## Final Environmental Impact Statement Talapoosa Mining Inc.'s Talapoosa Mine Project

**FINAL ENVIRONMENTAL IMPACT STATEMENT  
TALAPOOSA MINE PROJECT  
LYON COUNTY, NEVADA**

This Final Environmental Impact Statement (FEIS) responds to comments received during the public comment period on the Draft Environmental Impact Statement (DEIS), which analyzed impacts due to the proposed development of an open-pit gold and silver mining operation (the Talapoosa Project). The operation, with an expected mine life of seven to ten years, would include a 118-acre open-pit mine and two smaller pits (7 and 22 acres respectively), overburden and interburden disposal areas, ore stockpiles, a valley fill leach pad, process solution ponds, a processing plant, water treatment and supply facilities, administration and support facilities, and necessary ancillary facilities. Approximately 596 acres would be disturbed. Access would be provided by upgrading an existing road from U.S. Highway 95 Alternate. Two miles of new road construction are being proposed on the steeper areas and adjacent to the mine site.

FIGURE 4.2

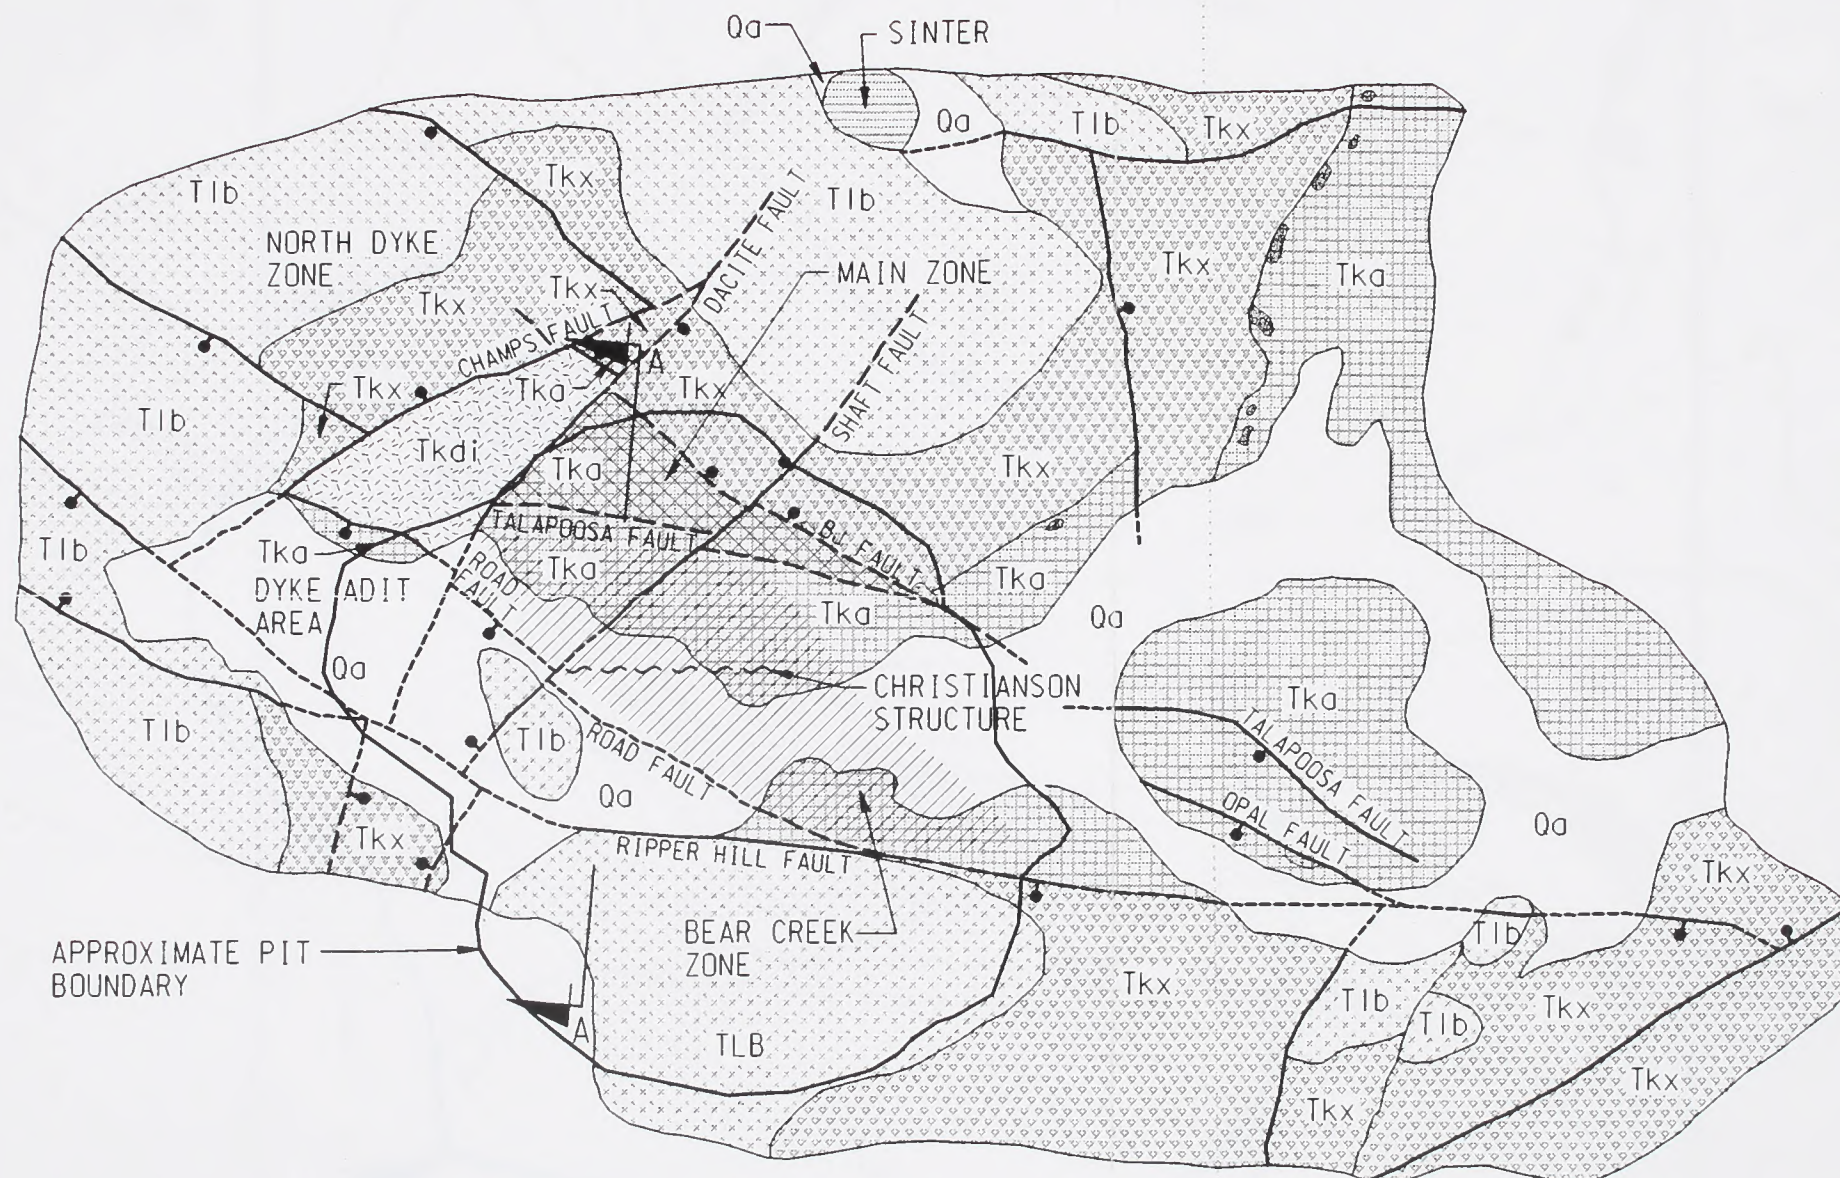
[ 19 ] Figure 3.7 of the DEIS refers the reader to Figure 3.10 for the location of cross-section A-A'. A-A' is not depicted on Figure 3.10. The FEIS should rectify this. Figure 3.7 should also provide a compass direction and vertical scale.

[ 25 ] The location of section A-A' is shown on figure 3.8, not 3.10 as stated. Figure 3.10 depicts the waters of the United States.

Figure 3.7, Geologic Cross Section A map has been corrected. See FEIS Figure 4.2 for the corrected map. Cross Section A-A' referenced on Figure 3.7 is found on DEIS Figure 3.8 and FEIS Figure 4.3.

### FIGURE E.1 GEOLOGIC CROSS SECTION ROCK BLIND SPRING

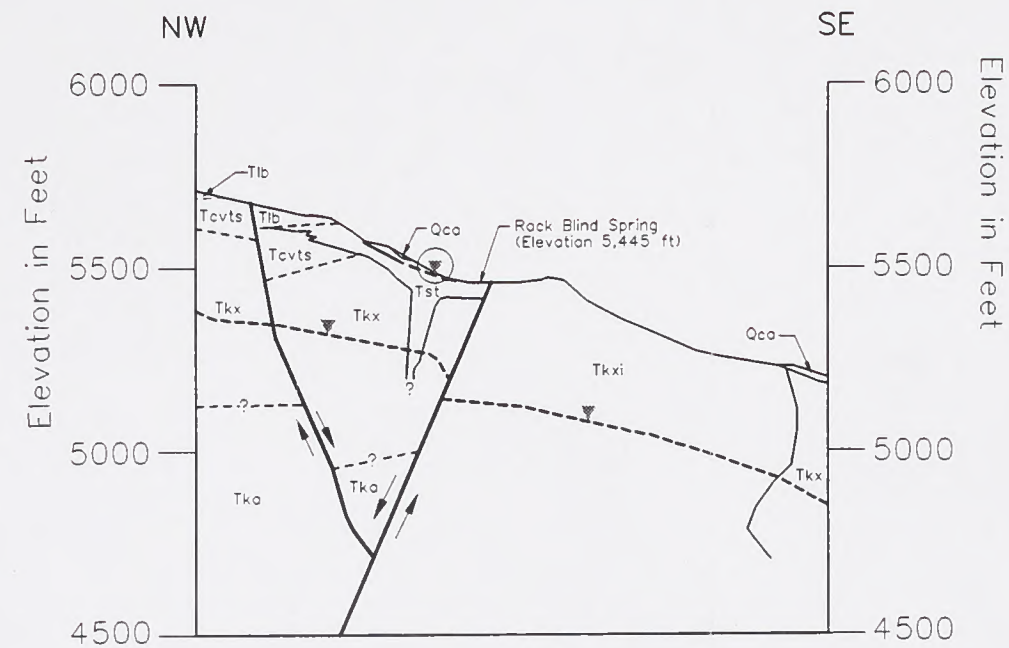
The impact of the proposed action on water resources results in a lowering of the water table in the basalt aquifer system but the cross-section on figure 3.12 shows the pit and lowered water levels will be in andesitic volcanic rocks; not basalt. If water-levels in the basalt aquifer are lowered, the FES should discuss how the flow of Rock Blind Spring could be affected.

Rock Blind Spring is a perched ground water system that occurs at the intersection of two major high-angle faults. It is not fed by the deeper ground water system of the volcanic bedrock aquifer. Rock Blind Spring is located in sinter, which is underlain by the rocks of the Upper Kate Peak formation which are much lower in vertical hydraulic conductivity (See Figure E.1 of the FEIS and Figure 7.1 of v.1 of WMC, 1996).
